BUILDING COMPLETION REPORT.

Undersigned begs to report that the construction of add. tall:
on plot No. 875 (Mar 343) Sheet J. 23, Jamshed Quarter owned by
Mr. Keoharji Talje
has been completed according to plans approved by the Municipal Corporation.
Orders are requested to file correspondence.

Subject:— Completion plan and completion certi-
ficate, for the Bungalow on plot No.
D/5.(New.343) J.M.3. Karachi.

COMPLETION FOR
PROPOSED ADDITIONS & ALTERATIONS TO BUNGALOW ON PLOT No D/5 SHEET J.M.3.
FOR
THE COSMOPOLITAN CO-OPERATIVE HOUSING SOCIETY LIMITED.
SCALE 8 FT TO AN INCH

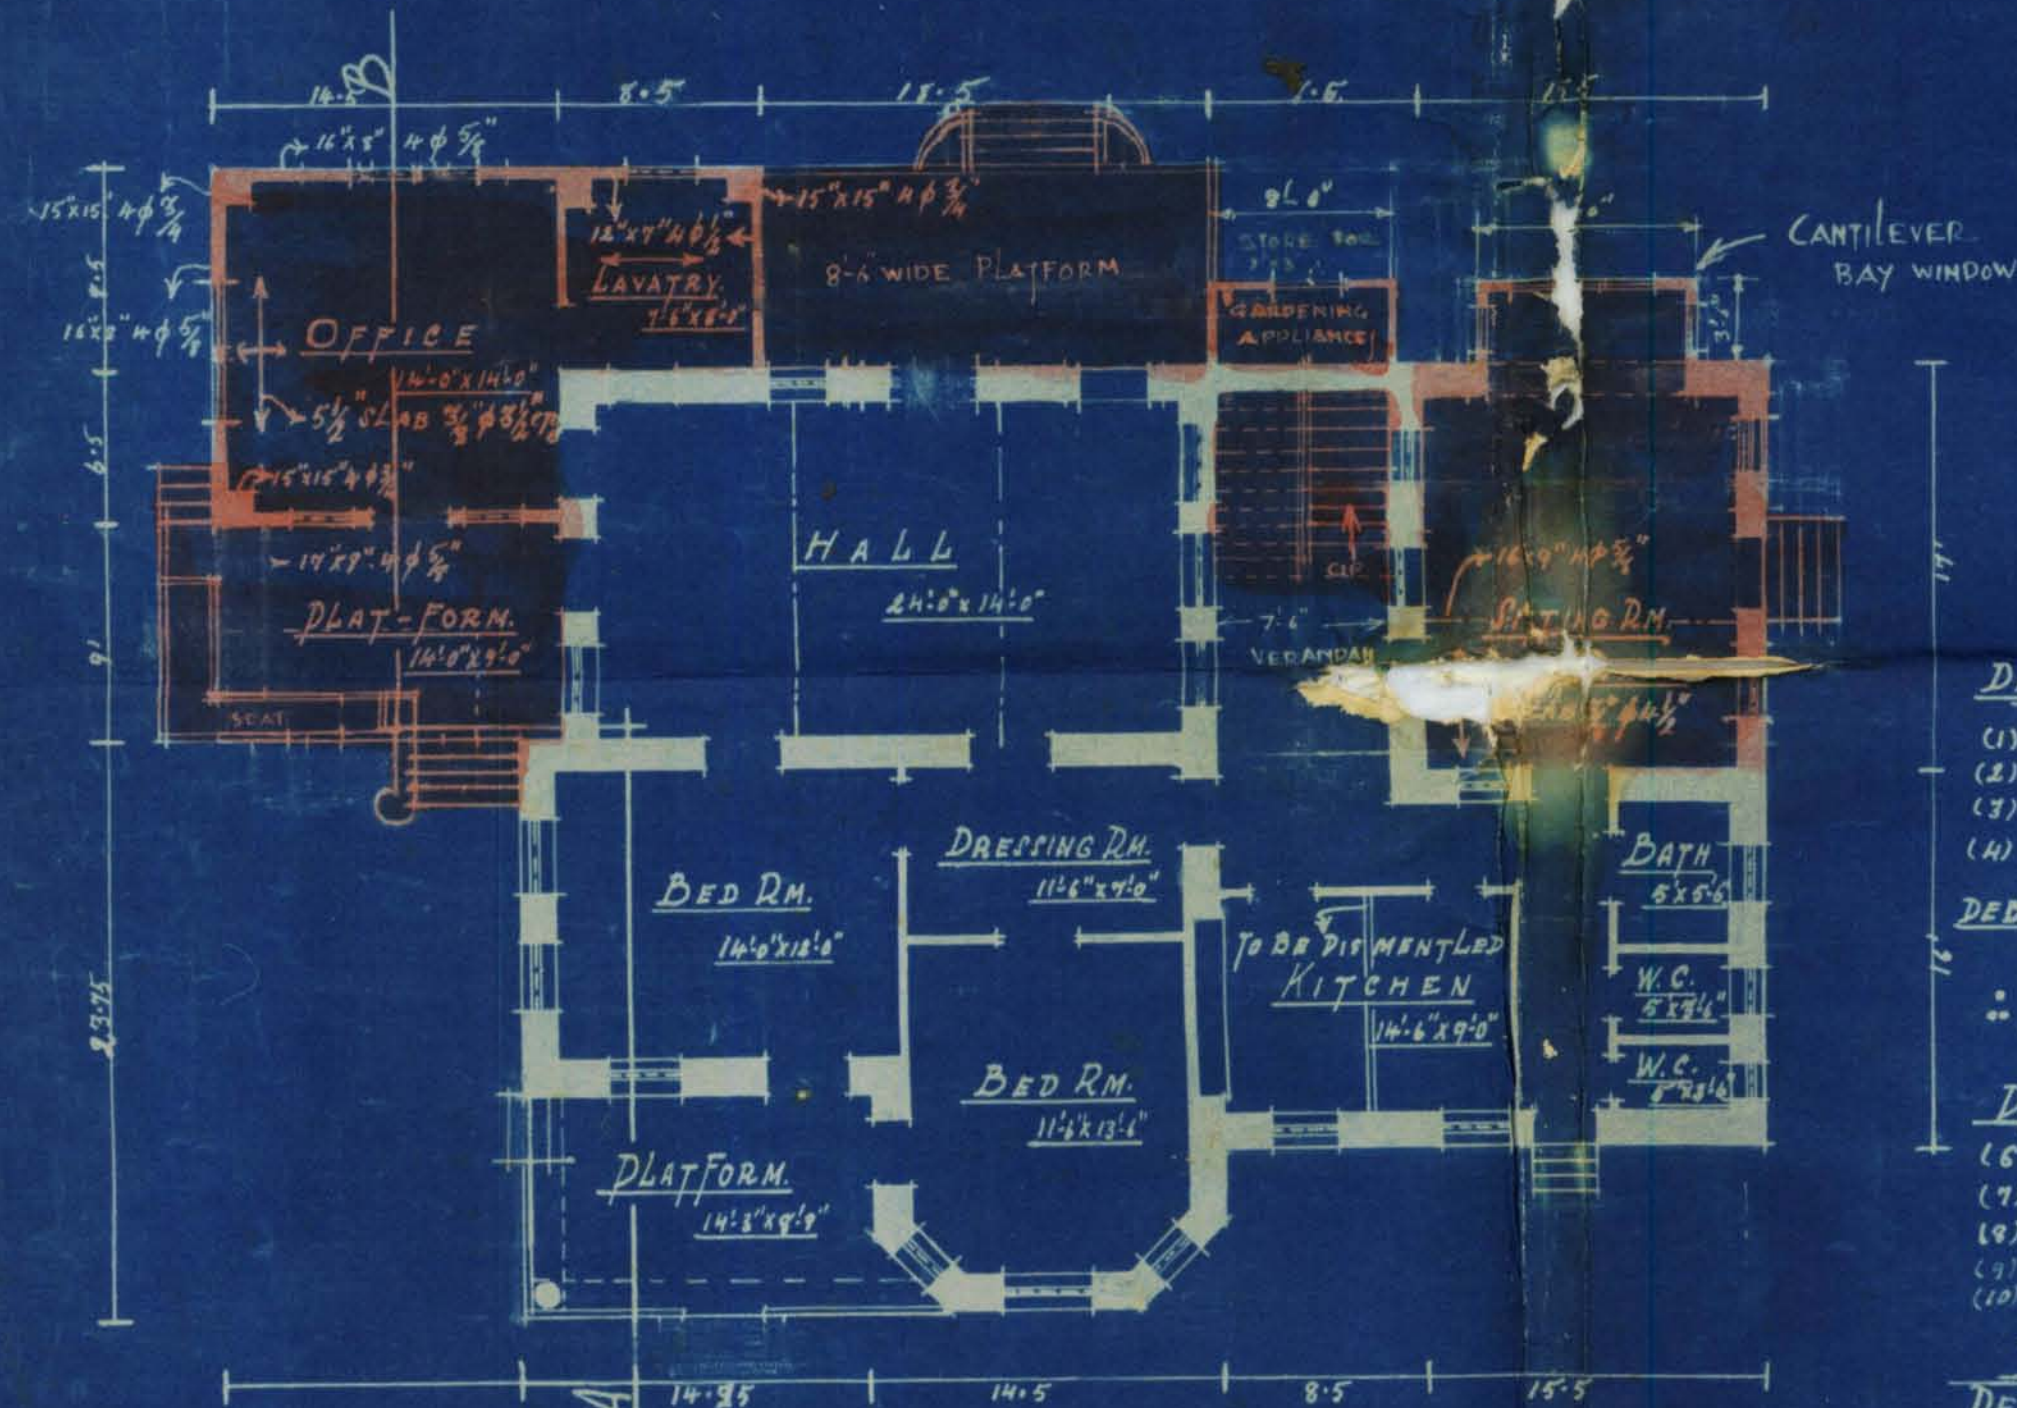
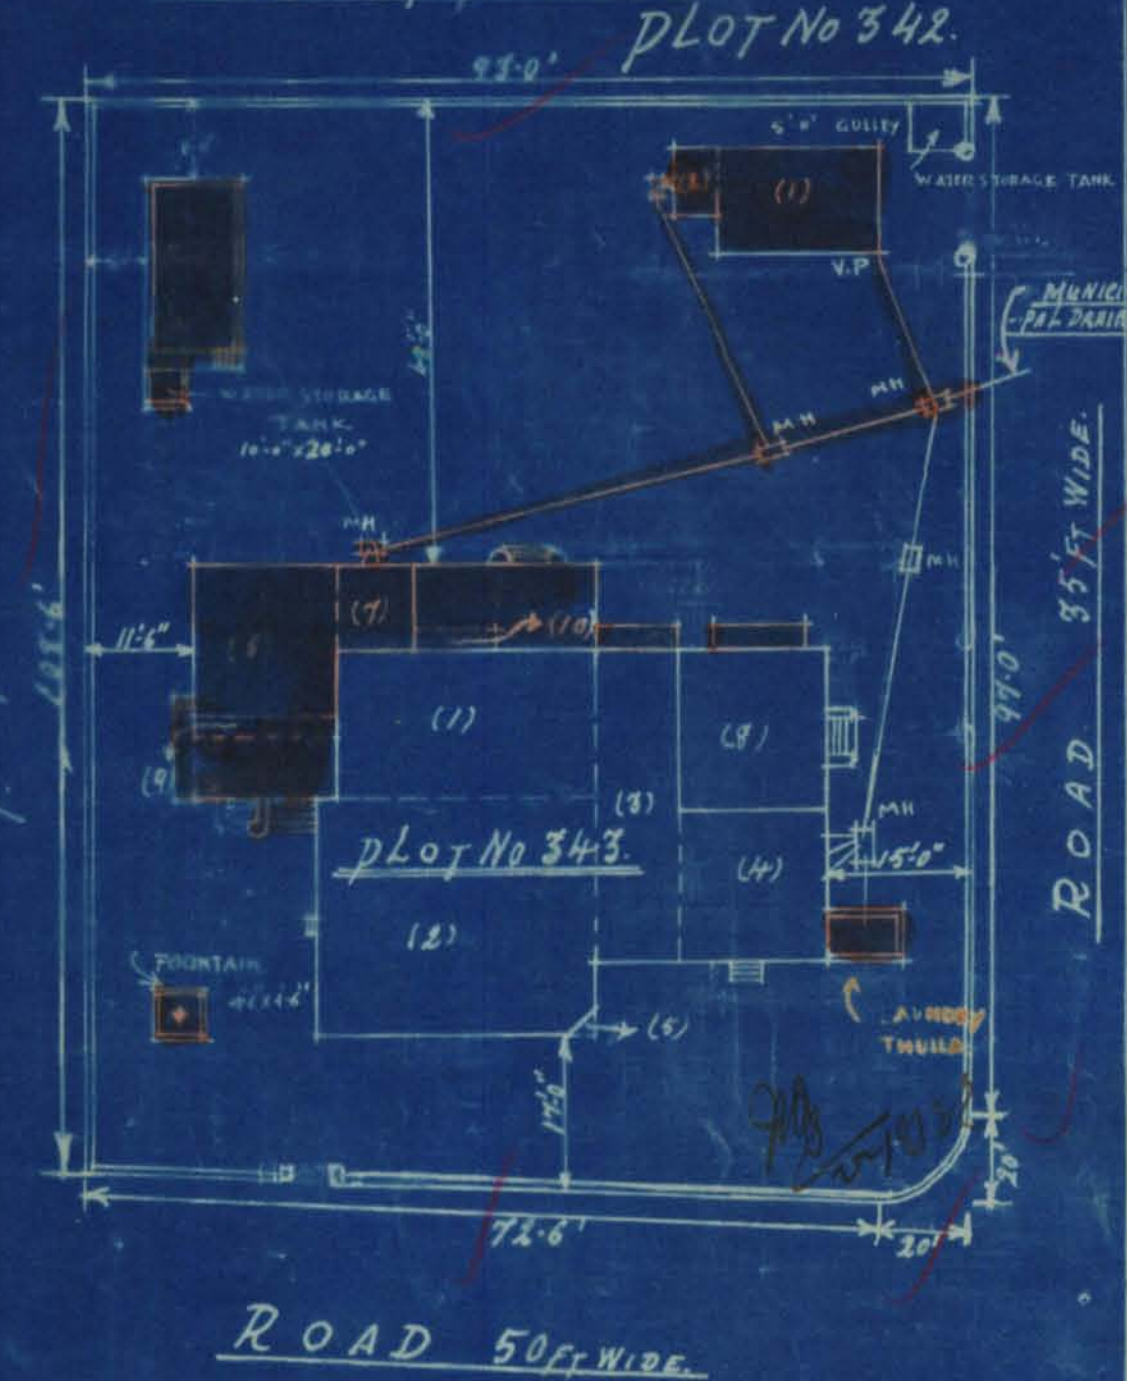
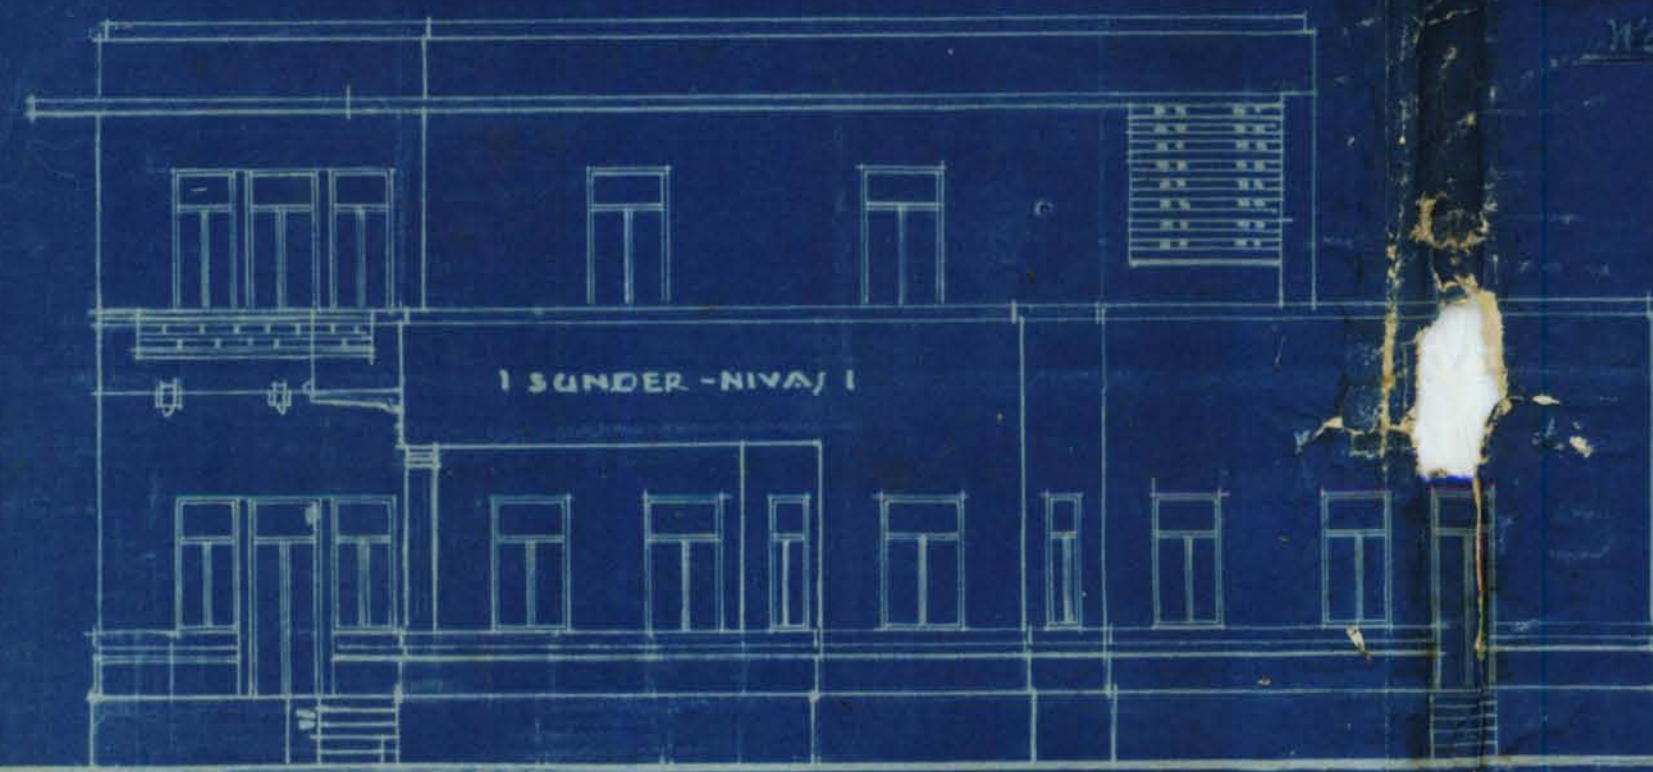
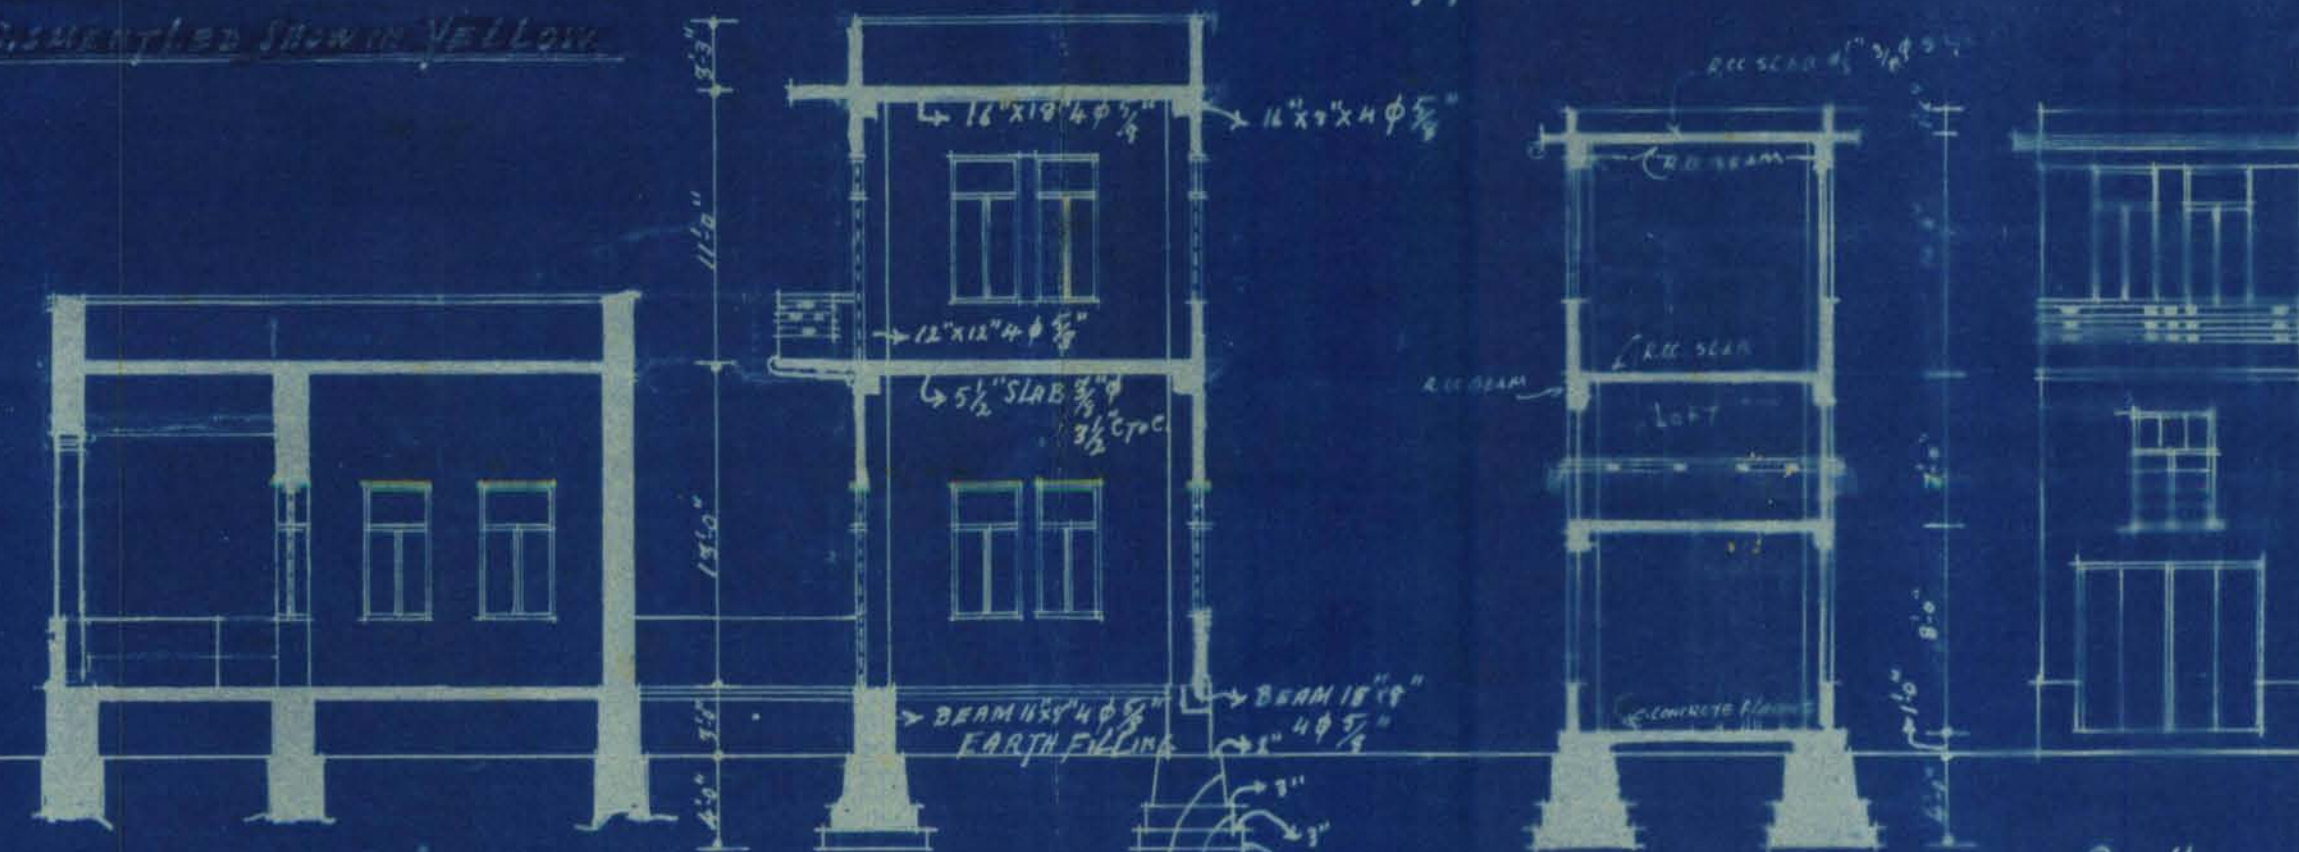
With reference to above, I have to request you to please comply with the objections of this office communicated to your architect on your behalf in letter No.L.O.P.276/39, dated 12th September 1939 and get the amended plan approved within seven days on receipt hereof, failing which, I regret, I shall be compelled to file prosecution against you, for building contrary to approved plan.

With reference to your application dated 16th August 1939,
with a plan for the proposed buildings/additions and alterations on plot
No. D/5 Survey Sheet No. J.M.3, Jamshed & Quarter,
I have to request you to comply with the following requirements—

(1) In the site plan measurements of the various rectangles
to be put down for the purpose of verifying the built up
area, and arrangements for joint measurements to be made.

(1) In the site plan measurements of the various rectangles to be put down for the purpose of verifying the built up area

With reference to your building on plot No. D/5 sheet
No. Jm 3, Jamshed, Quarter, I have to inform you that the
building as is being erected, or re-erected, differs from the approved
plan. You are therefore requested to make the building in
conformity with the approved plan on receipt hereof, failing which,
action will be taken under the Act which please note.

Built-up area checked along with the
architect (vide my report of 2/2 in this file).
No other objection -

*checked the built-up area & found it
correct.*
with architect.
3/11 *3/11*
